**Individual Permit Application**for a **Lake Encroachment Permit** under  
Chapter 11 of Title 29, § 401 *et seq.**For Lake Encroachment Permitting Use Only*

Application Number: 2015-044

Shoreline rip rap and retaining wall

**From:** Justus Cameron <justus@mckernongroup.com>  
**Sent:** Thursday, January 28, 2016 2:49 PM  
**To:** Cetner, Misha  
**Cc:** Eric Dutil  
**Subject:** Lake Encroachment & Shoreland Permit App Clarifications  
**Attachments:** 3658\_001.pdf

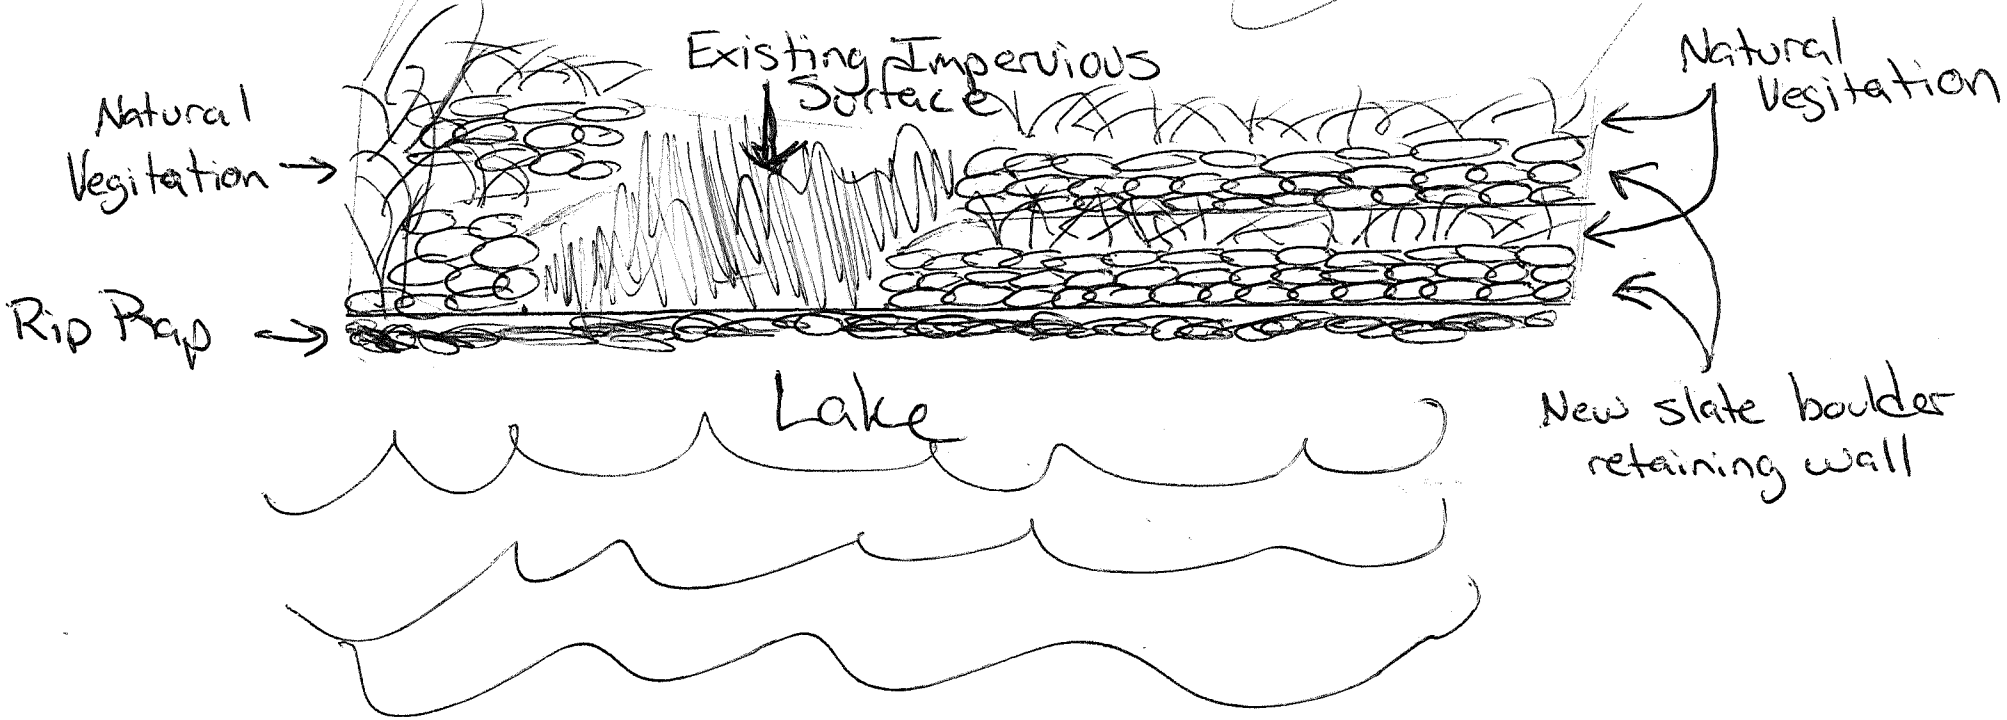
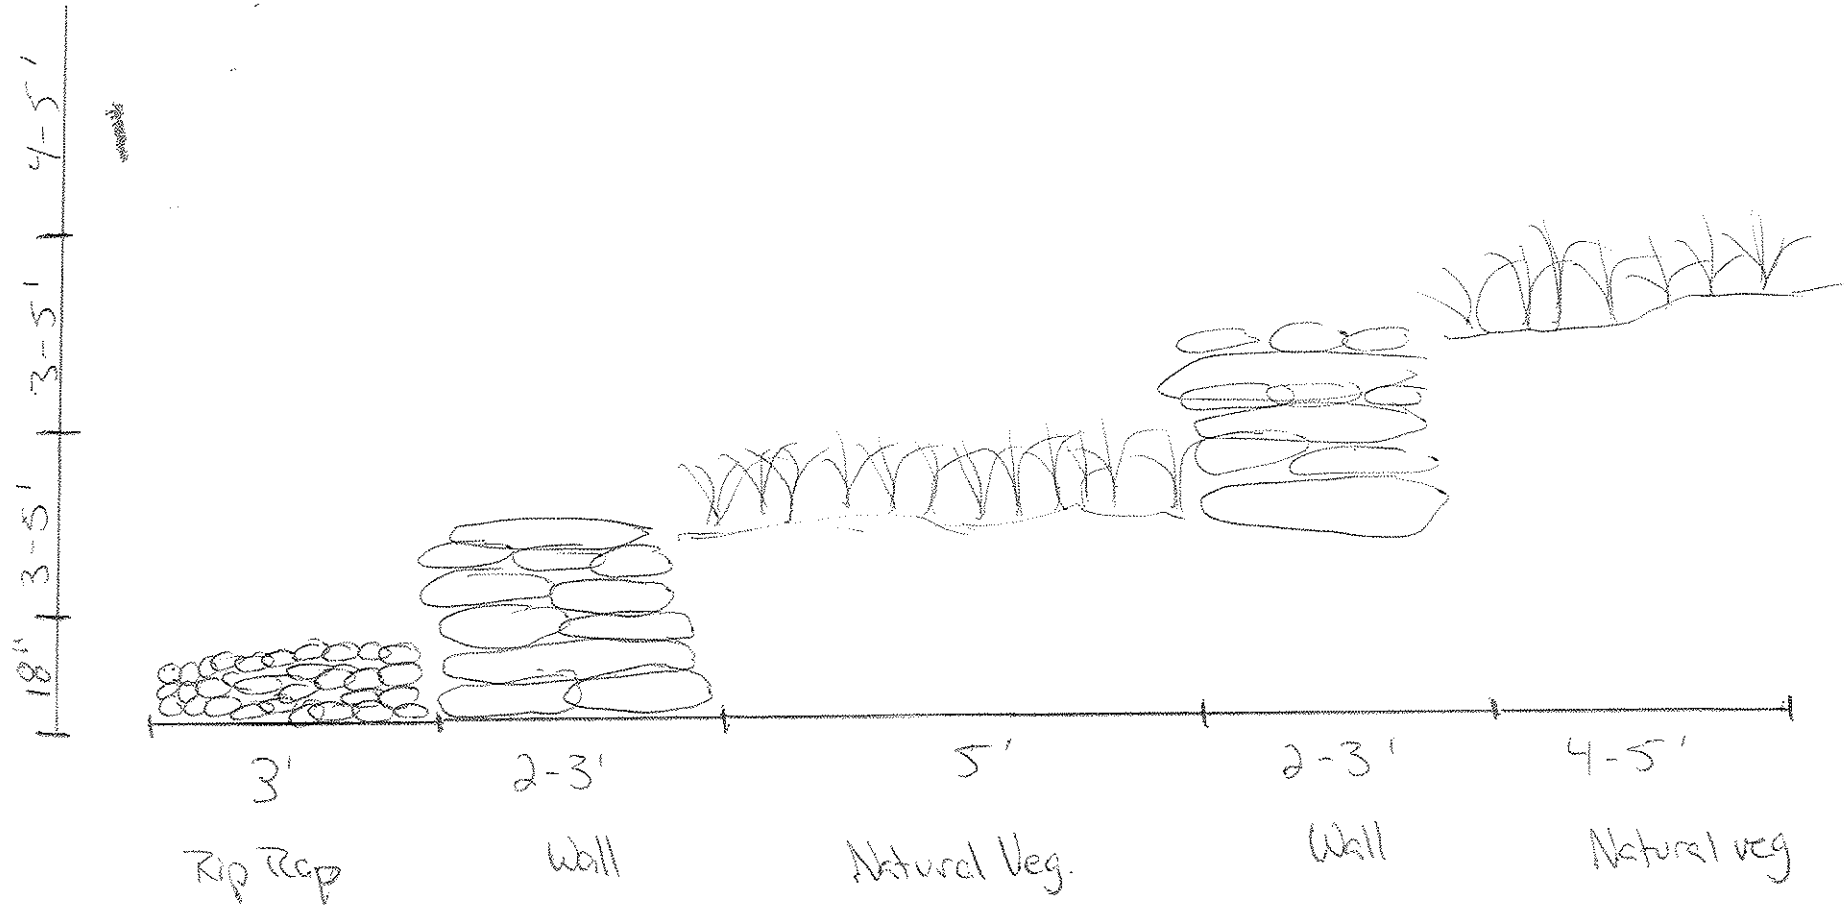
Below are the answers to your inquires. On the square footage of disturbed and re-vegetated area is way of on the 3,150sqft. That was the square footage on the original application that I must have got crisscrossed. In the attached document it has the dimensions so you can calculate it and it is around 1,050 sq.ft.

Total Disturbed  
1,050 sq ft

Added area to be  
planted w/ 15-20 evergreens

- There will be approximately 19 yards of rip rap
- The rip rap will be 5"-10" washed crushed slate
